IDIQ solicitation FA860123R0022	
What is the available fault current at the main service fused disconnect?	Three-phase fault current available at the point of delivery* at this time is a nominal 17,436 amperes (RMS) symmetrical, but could range from 17,221 to 18,458 amperes (RMS) symmetrical. Line-to-line fault current available at the point of delivery* at this time is a nominal 15,100 amperes (RMS) symmetrical, but could range from 14,914 to 15,985 amperes (RMS) symmetrical. Single-phase fault current available at the point of delivery* at this time is a nominal 19,615 amperes (RMS) symmetrical, but could range from 19,433 to 20,466 amperes (RMS) symmetrical. The fault current may be a different value in the future due to distribution system improvements and/or changes in the transformer(s) or load characteristics.*The point of delivery for the above location is the secondary side of the transformer(s).

34067_01 Floor

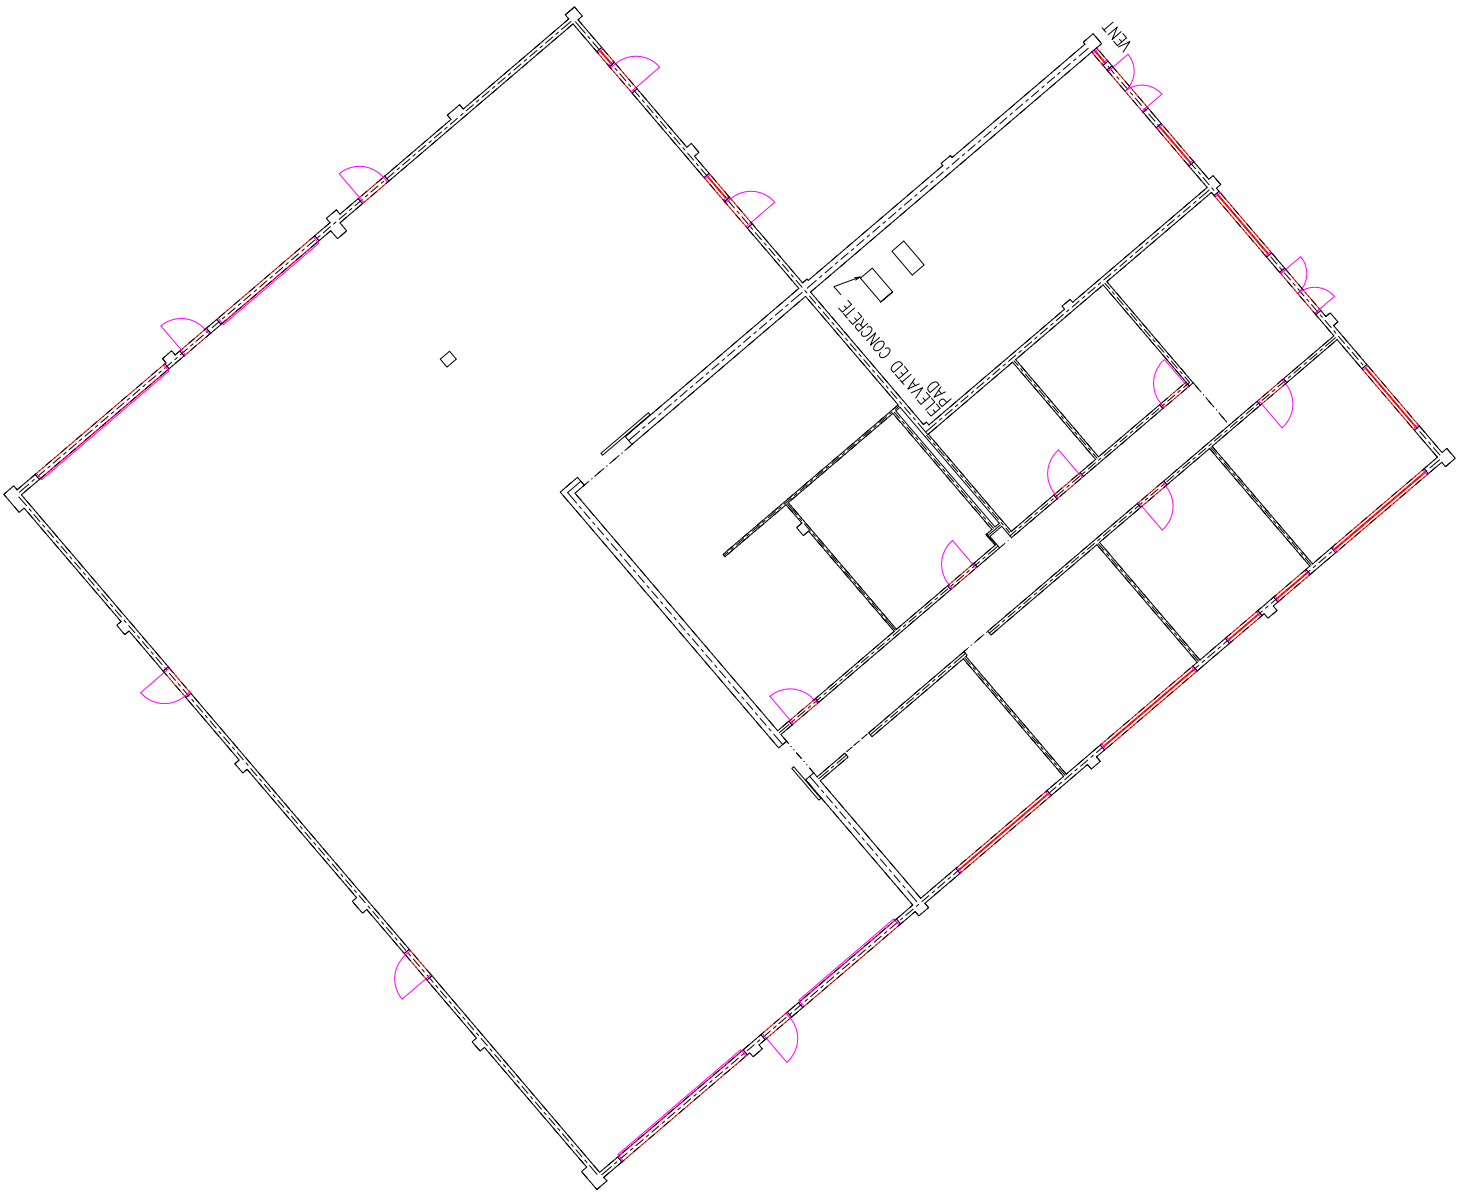
Can the existing floor plan of the building be provided in CAD and PDF format?	Yes, see the provided building floor plan on page 3.
The existing 200 panels are fed by 60A buckets in 600A main panel. The requirement is to install 200A panels. Do the feeders and breakers need to be upsized to 200A to provide full capacity of panels?	No, please bid it per the SOO.
Can an OSHA 510 Occupational Safety and Health Standards for the Construction Industry Certification and increased field experience be accepted in lieu of the OSHA 500 Train the Trainer certification for the Project Superintendent's role? The OSHA 500 pre-requisite of a bachelor's degree in occupational science or industrial hygiene is not a typical course of study for Journeyman/Foreman/Master Electricians.	<i>No, follow SOW (reference below) (https://www.osha.gov/otiec/courses/title_description) OSHA #500 - Trainer Course in Occupational Safety and Health Standards for the Construction Industry This course is designed for individuals interested in teaching the 10- and 30-hour construction safety and health Outreach Training Program to their employees and other interested groups. Using OSHA Construction Standards as a guide, special emphasis is placed on those topics required in the 10- and 30-hour programs as well as those which are most hazardous. Students are briefed on effective instructional approaches and use of visual aids and handouts. This course allows the student to become a trainer in the OSHA Outreach Training Program, to conduct both 10- and 30-hour Construction Outreach classes, and to issue cards to participants after verifying course completion. Students who wish to participate as authorized Outreach trainers in the OSHA Outreach Training Program must prepare a presentation on an assigned OSHA Construction Outreach Training Program topic individually or as part of a group and successfully pass a written exam at the end of the course. Minimum student contact hours: 26 Prerequisites: Students must successfully complete the OSHA #510 Occupational Safety and Health Standards for Construction and have five (5) years of safety and health work experience in the construction industry. A degree in occupational safety and health, a Certified Safety Professional (CSP) or a Certified Industrial Hygienist (CIH) designation may be substituted for two (2) years of work related experience. Students should obtain guidance on whether they meet this requirement from the OSHA Training Institute Education Center where they intend to receive the training. Authorized OSHA Outreach Training Program trainers are required to attend OSHA #502 - Update for Construction Industry Outreach Trainers at least once every four (4) years to maintain their trainer status</i>
